ADDENDUM NO. 1

REYNOLDSBURG CITY SCHOOLS
L.F.O. ATHLETIC & ECO LAB PROJECTS

Date: March 25, 2011

Addendum No. 1 to the Drawings and Project Manual, dated **March 17, 2011**, for **L.F.O. ATHLETIC & ECO LAB PROJECTS**, Reynoldsburg City Schools, 7244 East Main Street, Reynoldsburg, Ohio 43068; as prepared by Moody Nolan, Inc., 300 Spruce St. Suite 300, Columbus, OH 43215.

5 **DETAIL**
 SCALE 1 1/2" = 1'-0"

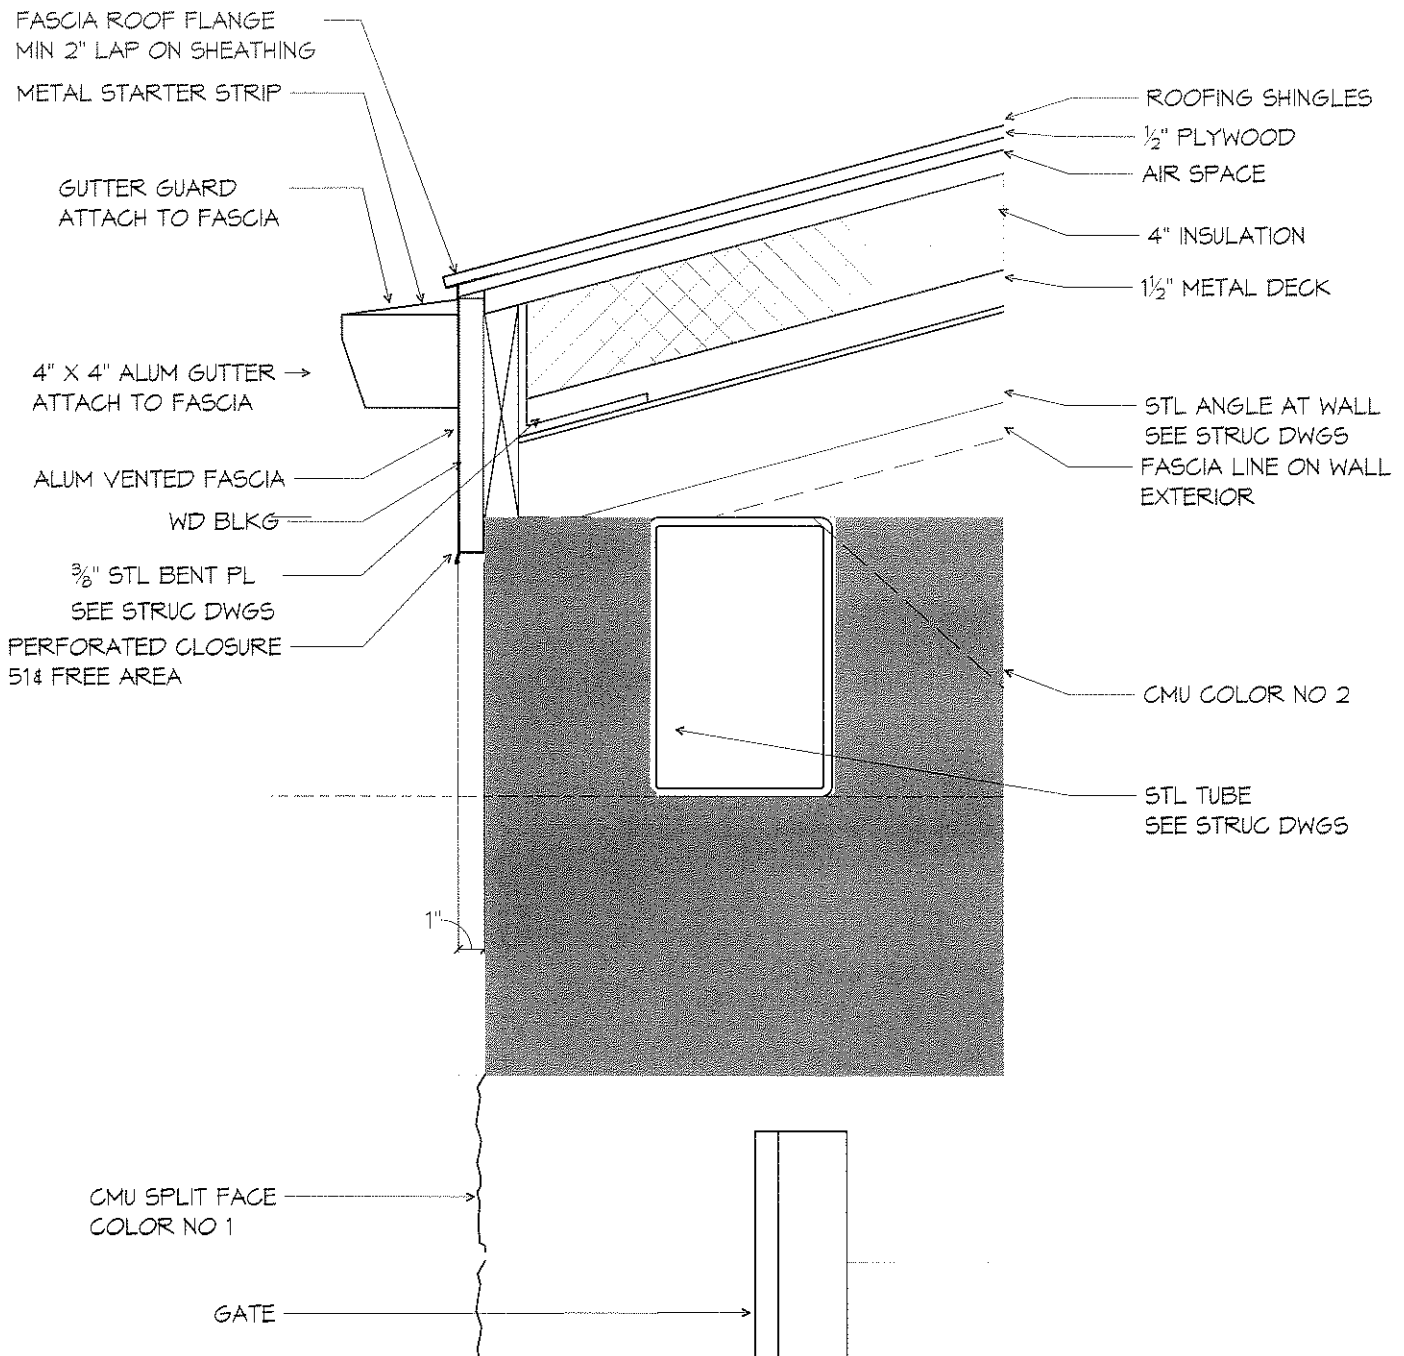
- Item 1-20 Vol. 1, SHEET Aa8.1
A. **REVISE:** Section 5, missing information provided, see A-SK04.
- Item 1-21 Vol. 1, SHEET Aa8.2
A. **REVISE:** Fixture mounting height schedule modified, see A-SK05.

ENLARGED TOILET RM

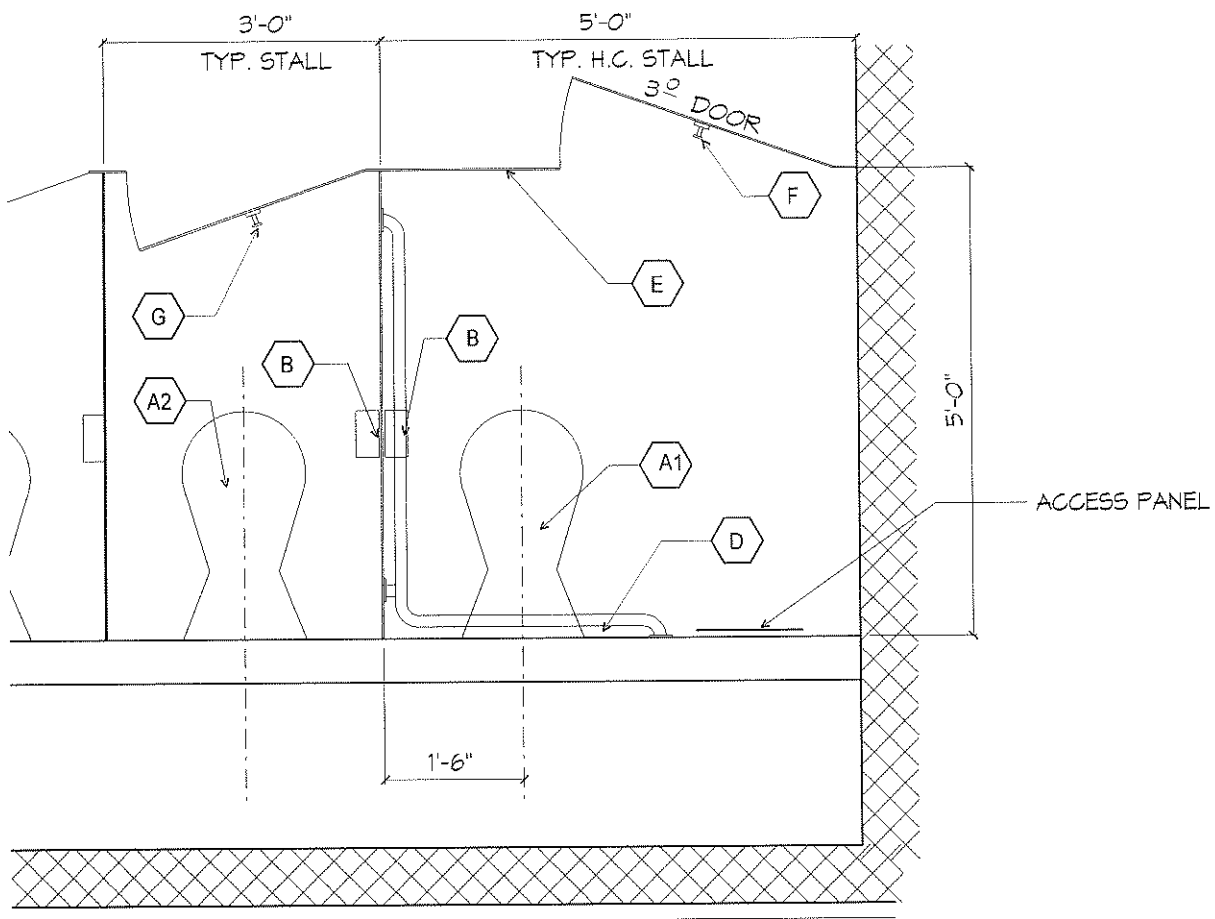
- Item 1-22 Vol. 1, SHEET Aa8.2
A. **REVISE:** Fixture mounting height schedule modified, see A-SK06.
- Item 1-23 Vol. 1, SHEET Aa8.3
A. **DELETE:** Bollard detail 5/Aa8.3.
